Subject: Calvert Cliffs Nuclear Power Plant
Units Nos. 1 & 2, Dockets Nos. 50-317 & 50-318
Follow Up Actions Resulting from TMI-2 Incident

DRAWING CHANGE NOTICE

JOB NO.	DRAWING NO.	REV. NO.
11865	6750 IE-79 SH. 27B	
DCN NUMBER	DATE	
IE-79-2006	10-12-79	
PROJECT APPROVAL		
<i>JMS</i>

JOB NO.	DRAWING NO.	REV NO.
11865	6750 M-633-2	<div style="border: 1px solid black; width: 50px; height: 20px; margin: 0 auto;"></div>
DCN NUMBER M-633-2-2000		DATE 10-4-79
PROJECT APPROVAL <i>JMS</i>

JOB NO.	DRAWING NO.	REV NO.
11865	6750 IE-79 SH. 27B	
DCN NUMBER	DATE	
IE-79-2006	10-12-79	
CONTINUATION SHEET		
PAGE	2	OF 4

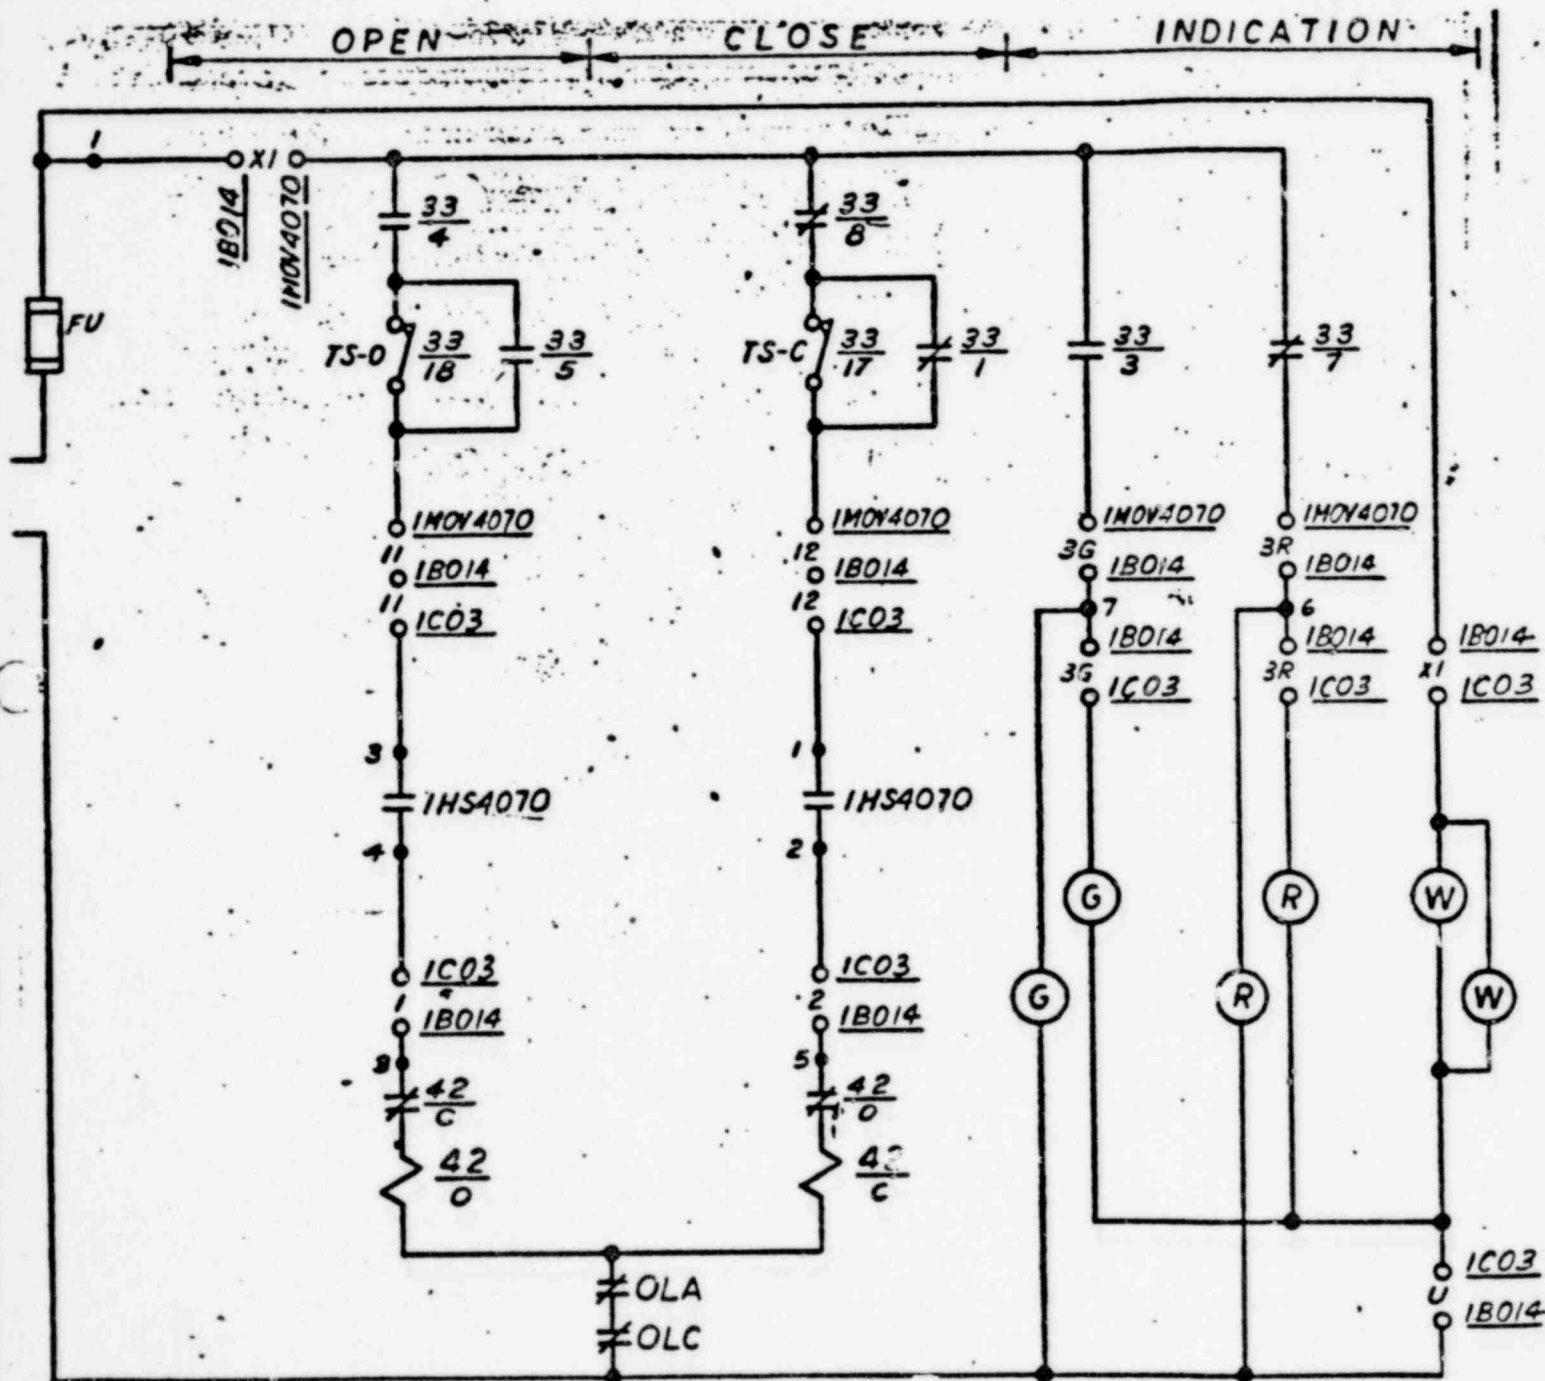
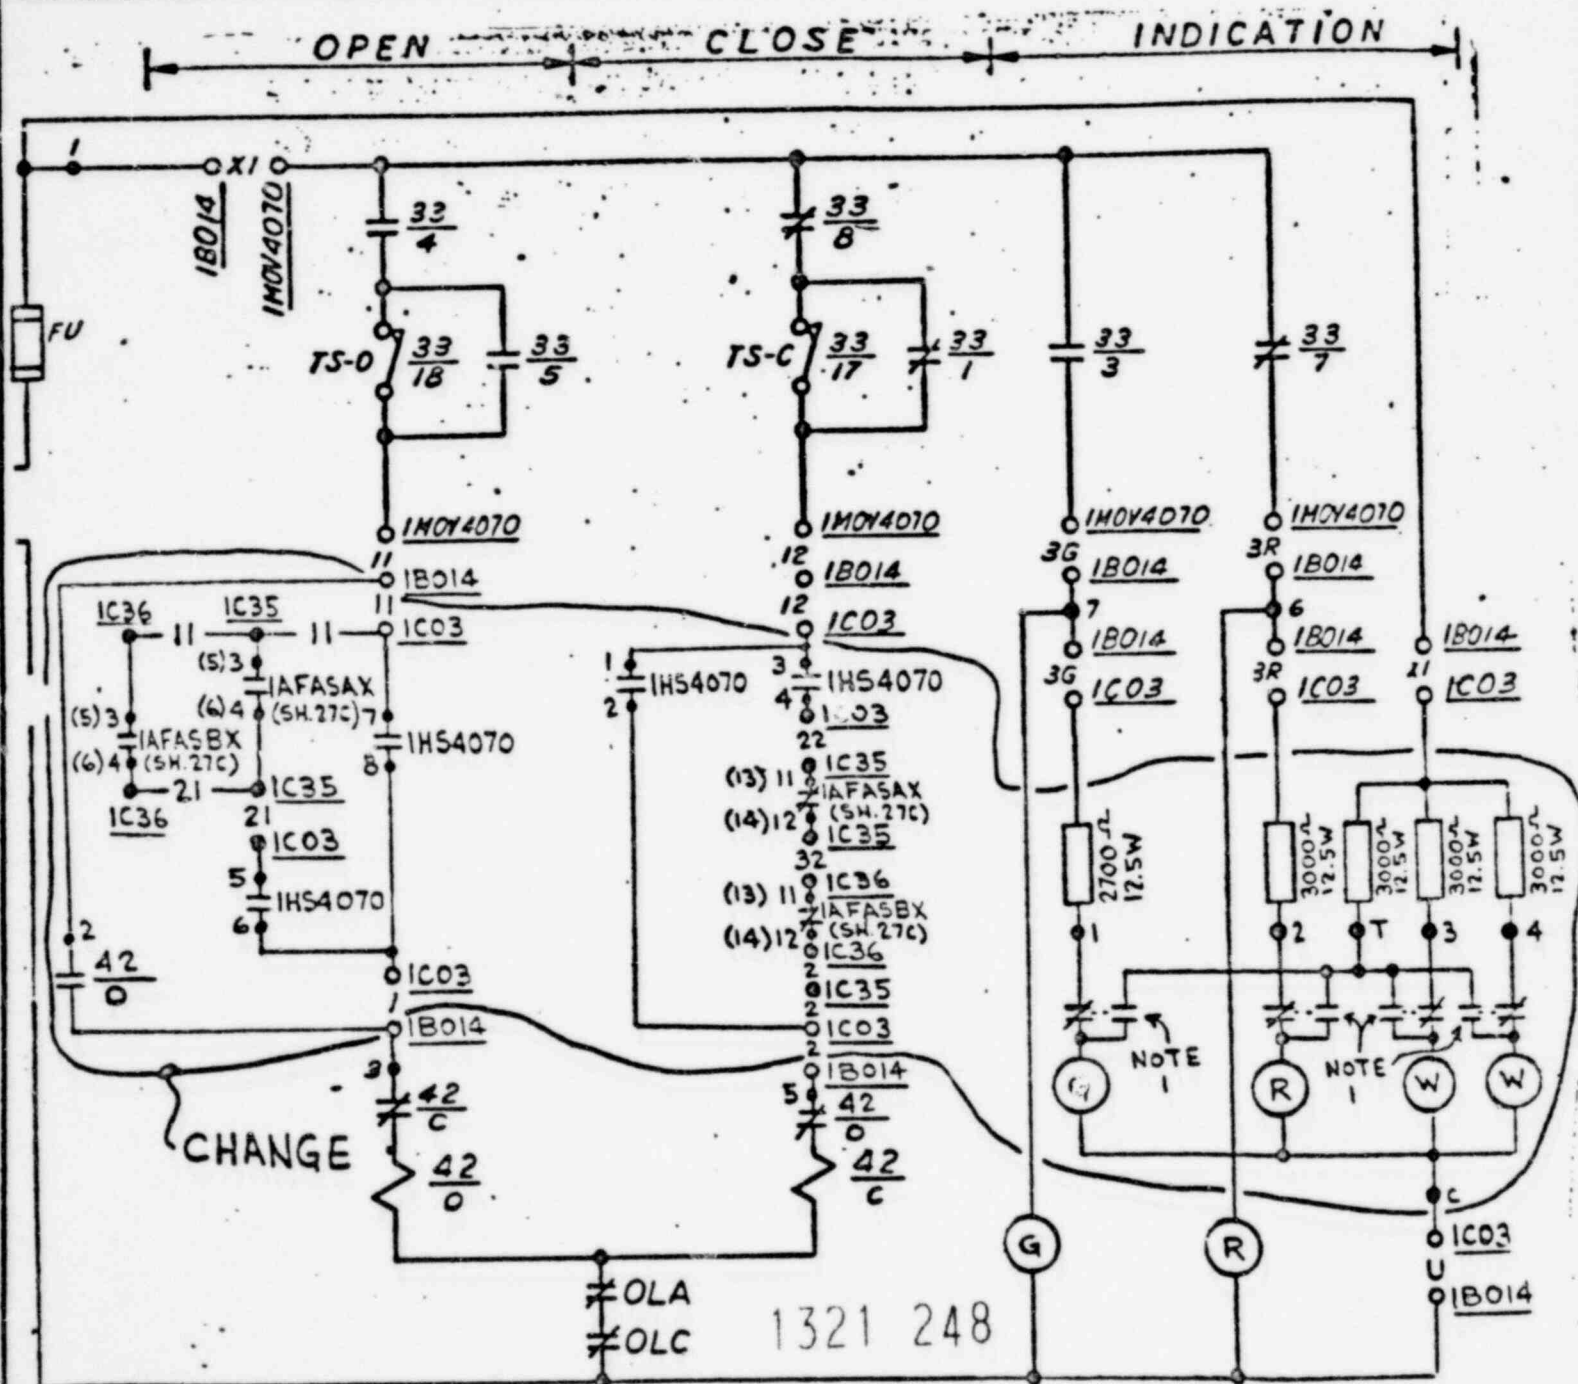
REASON FOR CHANGE: FCR 79-1035 UNIT NO 1

SCHEME 1B1414
VALVE SHOWN IN FULL OPEN POSITION

BEFORE

AFTER

1. PUSHING IN ON LIGHT CHANGES CONTACT STATE
2. TERMINAL NOS IN () PERTAIN TO SCH. 1B0414

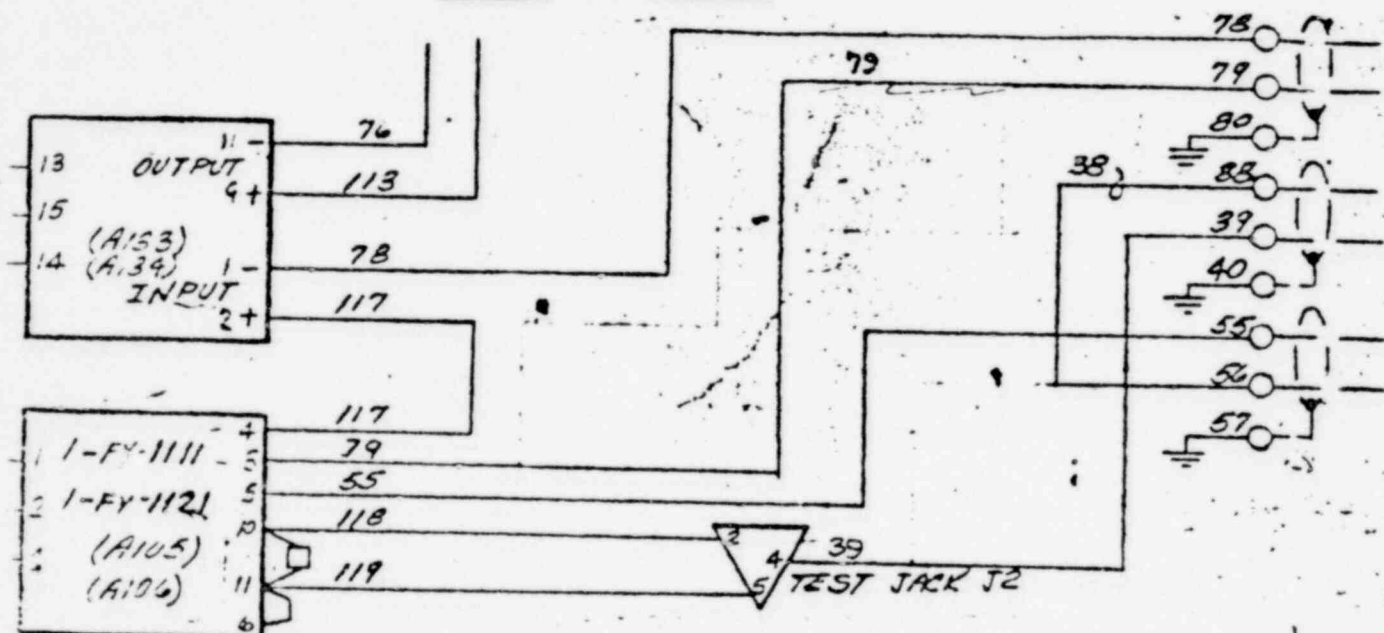
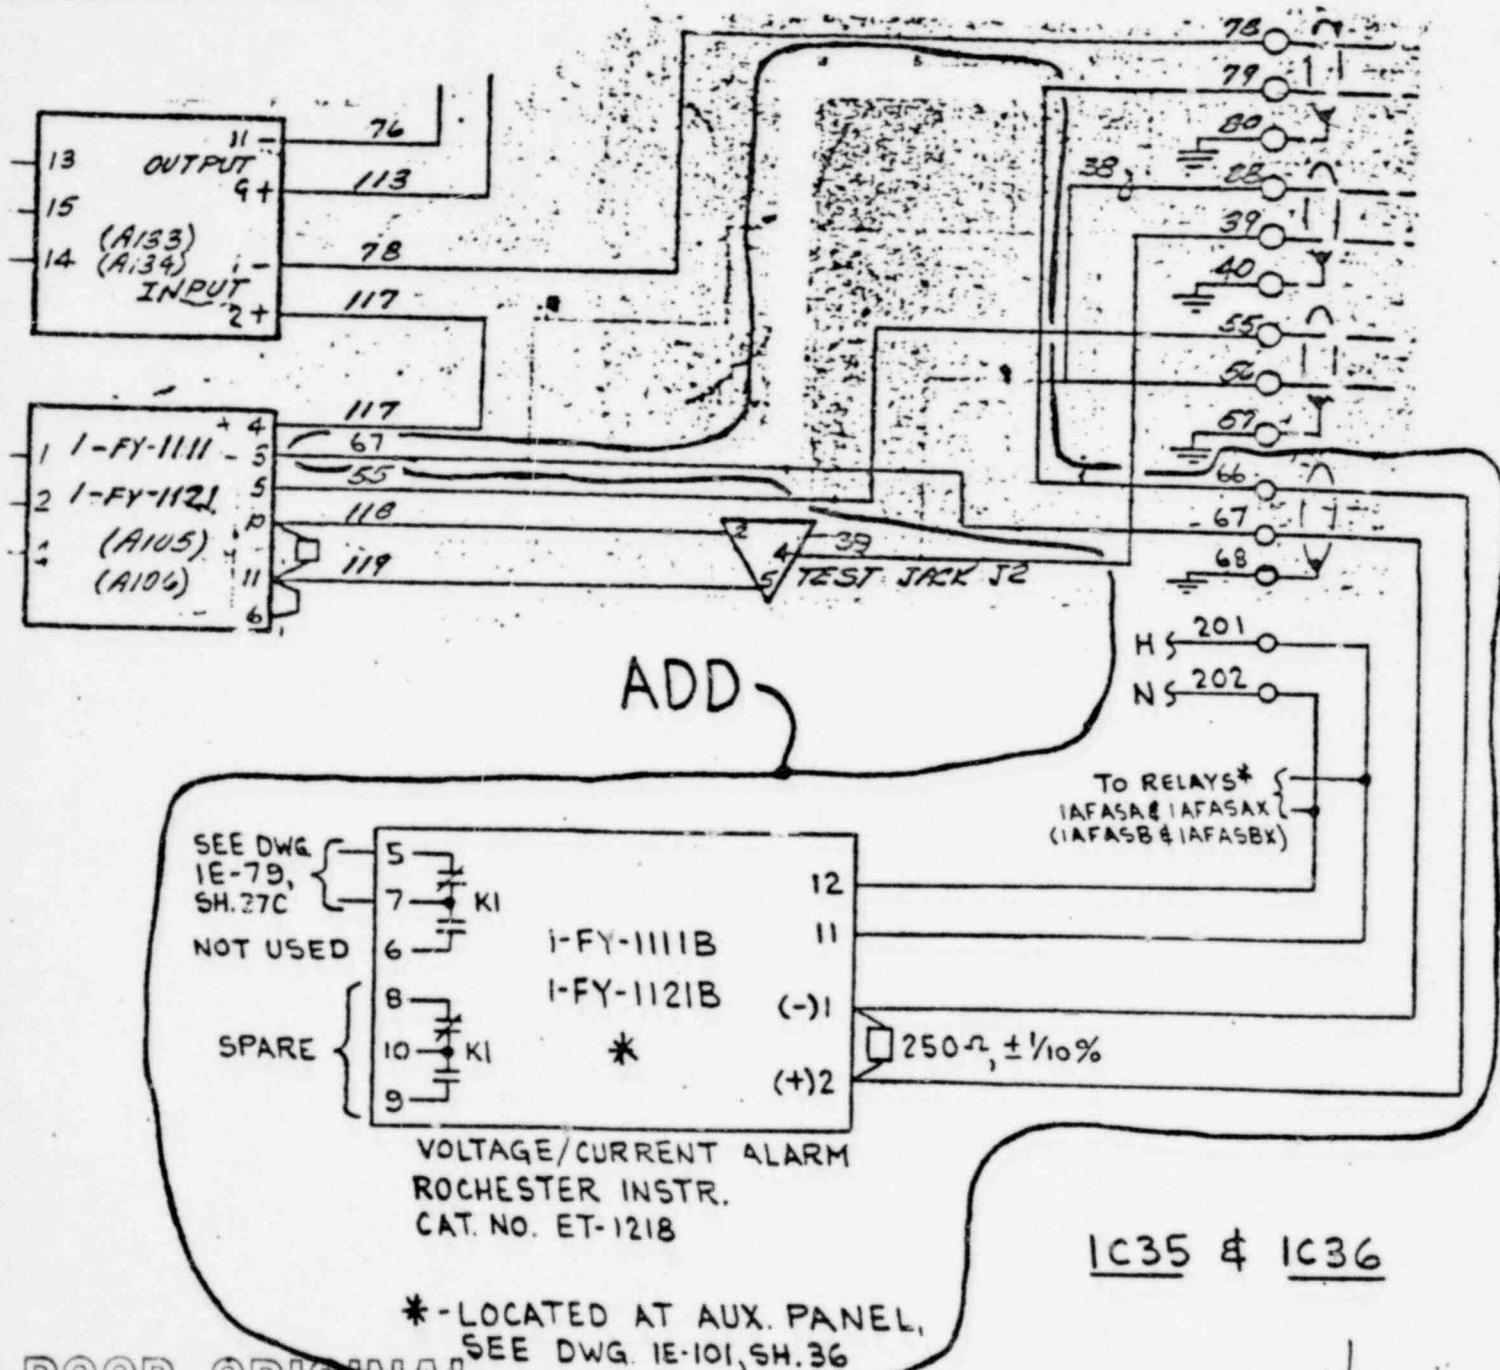
REASON FOR CHANGE: FCR 79-1035 UNIT NO. 1
(REF MFR# WD56B2456)

IC35 & IC36

BEFORE

AFTER
